CITY OF SACRAMENTO
CALIFORNIA

**PLANNING DIRECTOR'S SPECIAL PERMIT
FOR SINGLE FAMILY RESIDENTIAL IN A PUD**

FILE: P00-145

PROJECT NAME: Northpointe Park Village 17

FIRST FLOOR PLAN
● BONUS OPTION
SCALE: 1/4"=1'-0"

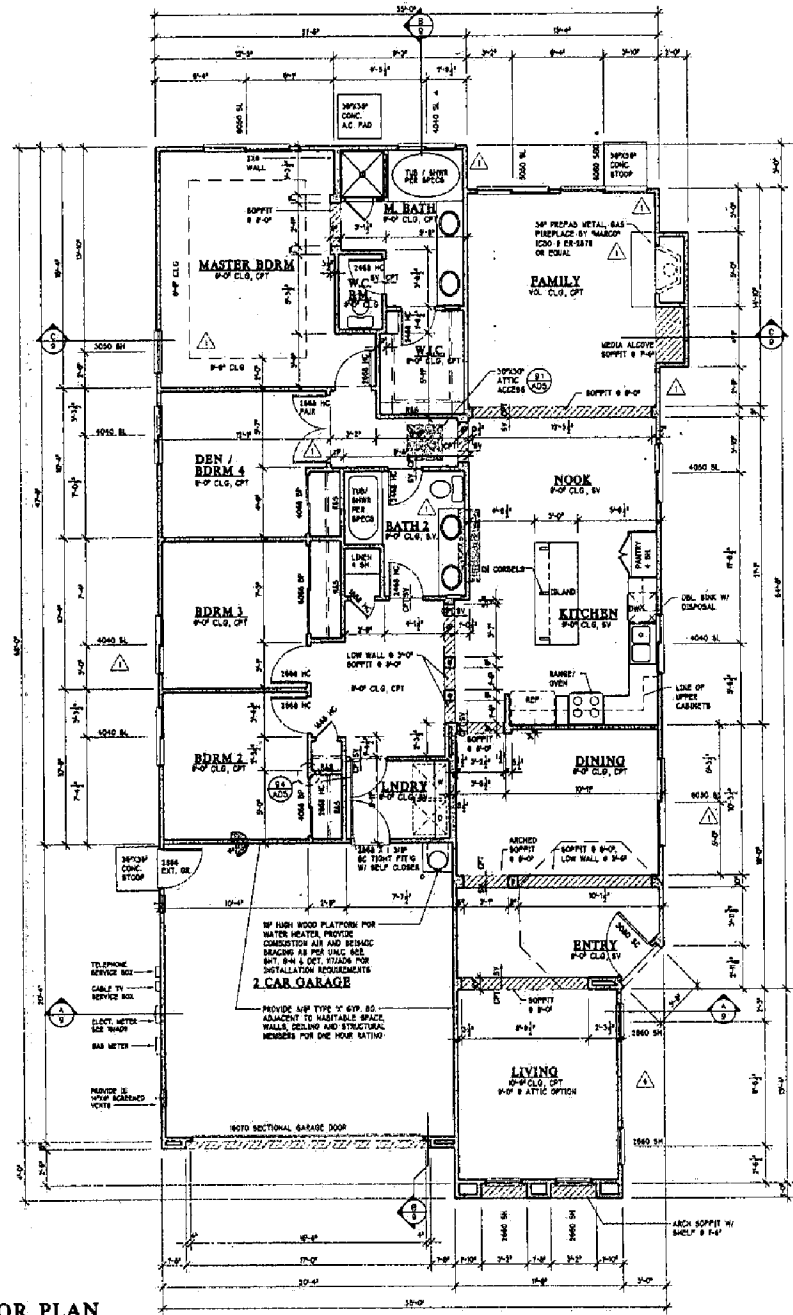
Plan 2: Optional second floor bonus room (attic conversion) increases roof pitch from 5:12 to 8:12 (242 sq.ft.); diagonally oriented front door recessed back along the side elevation of the house.

However, planning staff expressed concern about the diagonally-oriented front entry on Plan 2 which is recessed back on the side elevation, contrary to the goal in the City's Single Family Residential Design Principles that states that "the main entry feature (which shall not be the garage door) should be prominently displayed on the elevation facing the street" and the City Zoning Code which specifies that "the main entrance to the single-family dwelling unit shall be from the front yard or the street side yard" (Section 17.24.050, Footnote 26.j); and while this arrangement is especially suitable for corner lots (and though a prominent entry structure is provided on all three elevations), the potential exists for creating a constricted entry corridor between the side elevation and neighboring side yard fencing when placed on interior lots. The applicant has therefore agreed to pair the Plan 2 (when located on an interior lot) with the recessed garage of the Plan 3 such that openness is maintained adjacent to the front door of the Plan 2, instead of a six foot high side yard fence (see Exhibit 7); or alternatively, a courtyard feature (as shown on Exhibit 8) shall be required and the house restricted to wider than typical/minimum width interior lots with a greater than minimum setback on that side of the house.

- c. **Plan 2** shall be favored on corner lots; when constructed on interior lots, Plan 2 shall be paired with the recessed garage side of Plan 3 (as shown on Exhibit 7); otherwise, a courtyard (as shown on Exhibit 8) shall be required for the Plan 2, with a minimum interior side yard setback of seven (7) feet on the courtyard side of the house; this courtyard may be offered as an option when the Plan 2 is located on corner lots or paired with the Plan 3, but is otherwise required;
